CHAMPLAIN HUDSON POWER EXPRESS

HUDSON 7'S QUESTIONS AND CONCERNS

FEBRUARY 25, 2021

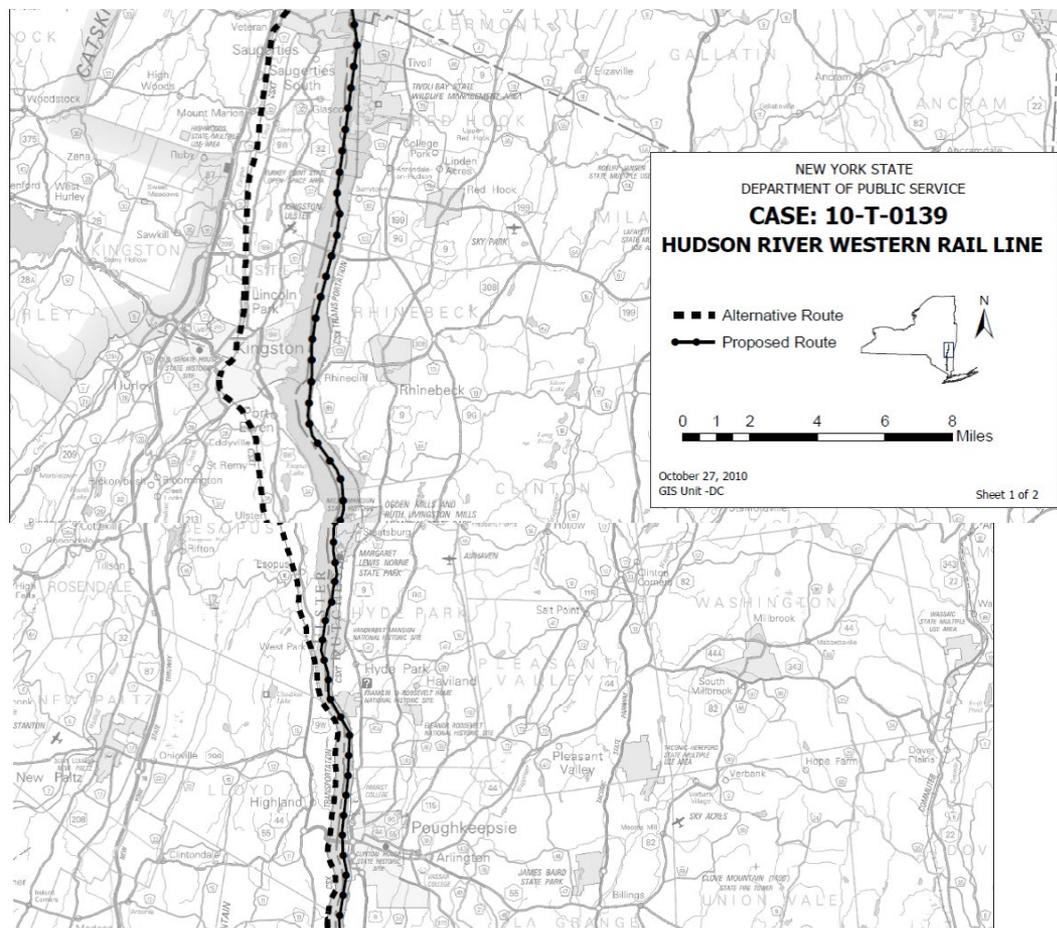
TDI indicated that the NYS Thruway Authority would not approve the transmission cables installed in its right-of-way at the start of the project in about 2008. Pilgrim Pipeline proposed using the NYS Thruway right-of-way in 2015. Has TDI contacted the Authority since 2008 to ask if the transmission cables can be installed in the right-of-way? If not, why not?

For the Pilgrim Pipeline, the route, access roads, and staging areas have already been identified. This route would resolve concerns of the Hudson 7, environmental groups, and the maritime community. Could the Pilgrim Pipeline design be used for the transmission cables?

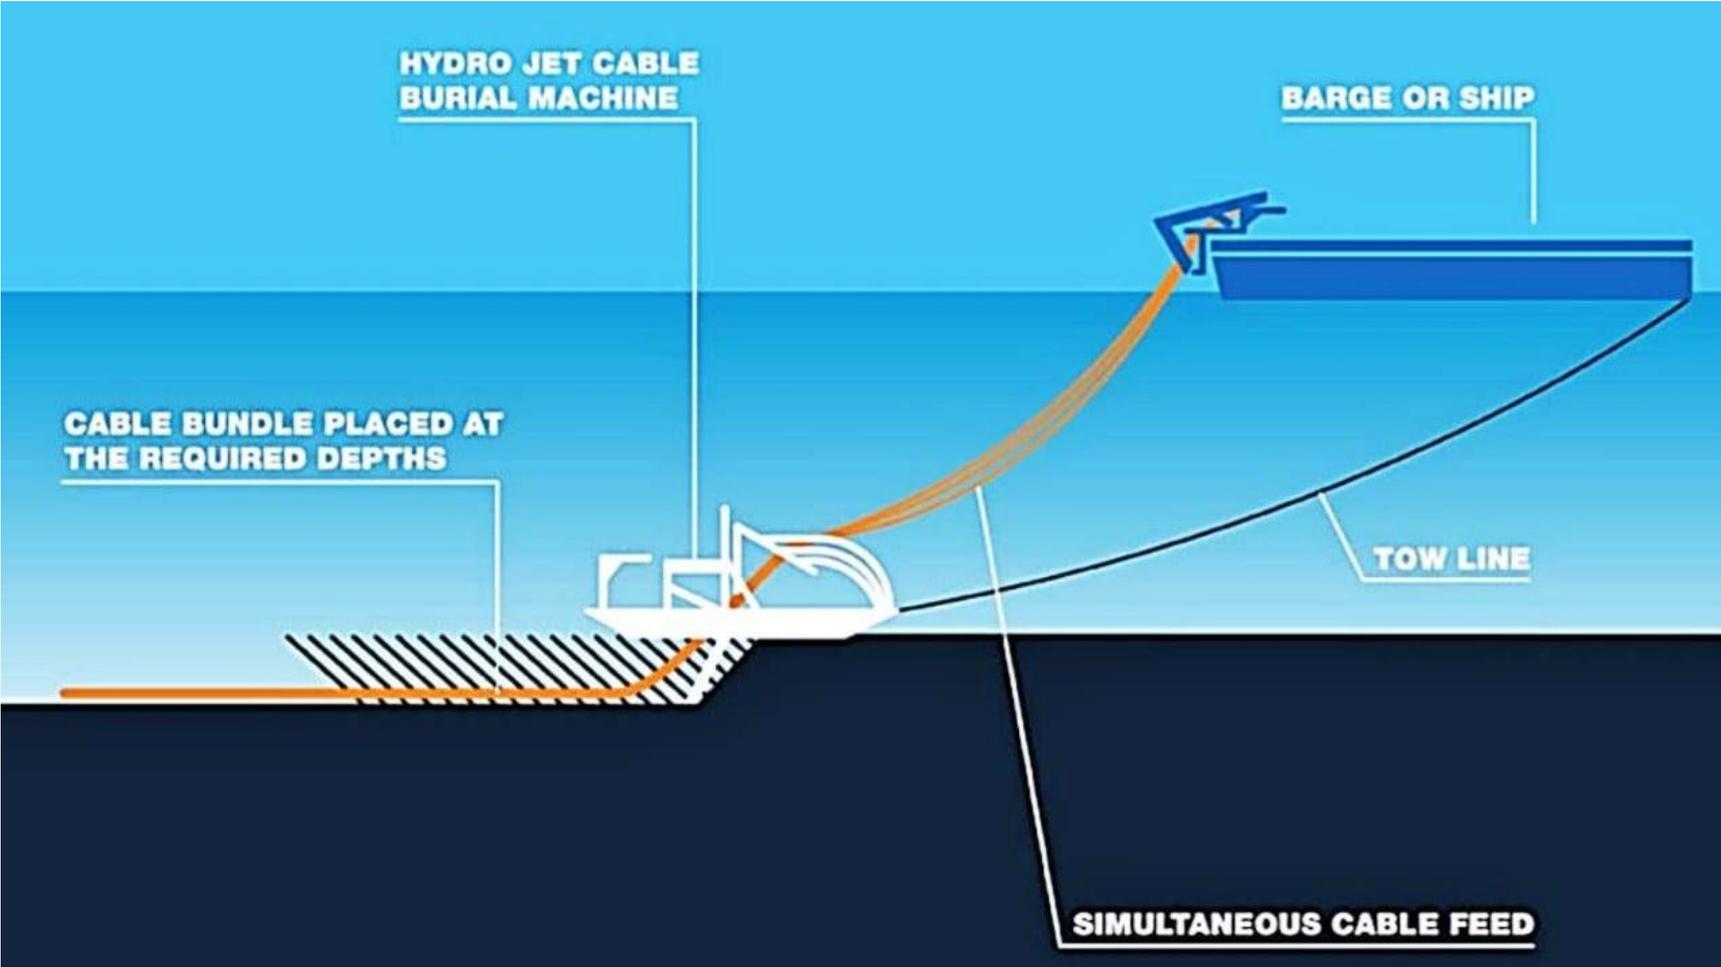
The transmission cable in the vicinity of the Esopus intake should be relocated to the other side of the river.

It appears that the proposed route of the transmission cable runs between Poughkeepsie's two intakes. Construction as proposed would present an unacceptable risk. How will the construction be performed in this area? How will the intakes be protected? The transmission cable in the vicinity of Poughkeepsie's should be relocated to the other side of the river.

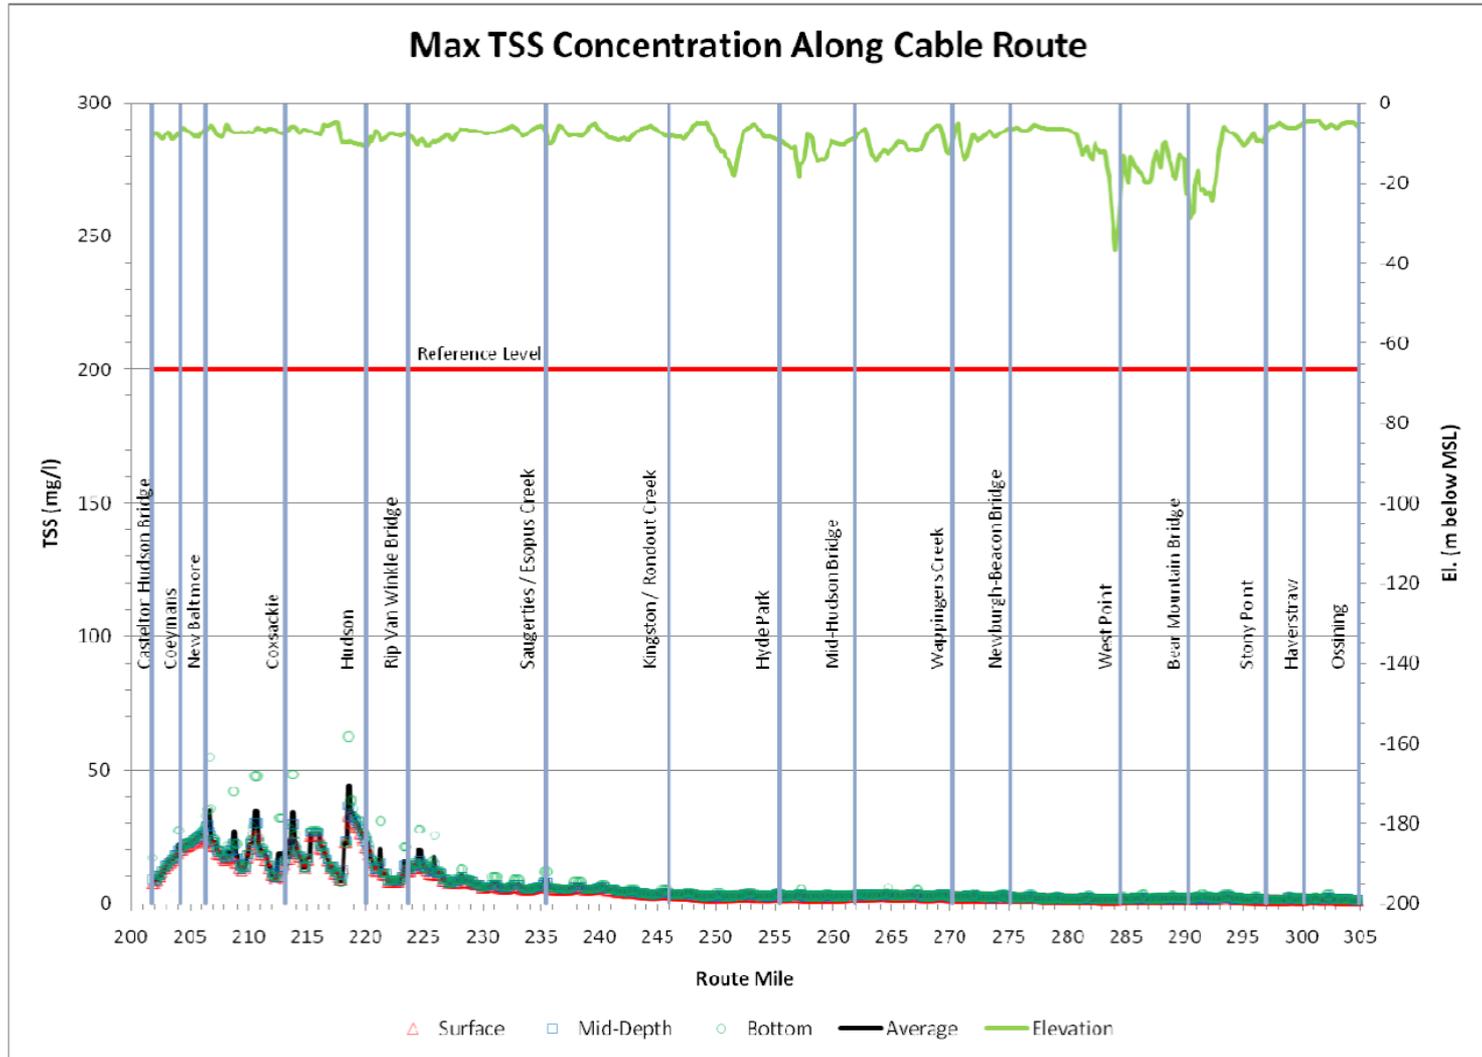
The Project's Water Quality and Sediment Plan indicates that the operation will be modified only if Maximum Contaminant Levels in finished drinking water are exceeded. Project shutdown would only occur if modifications do not address the contamination. This protocol, coupled with inadequate monitoring described above, could result in contaminated water reaching taps for extended periods before modifications to the project are even considered or implemented, or before construction is stopped.
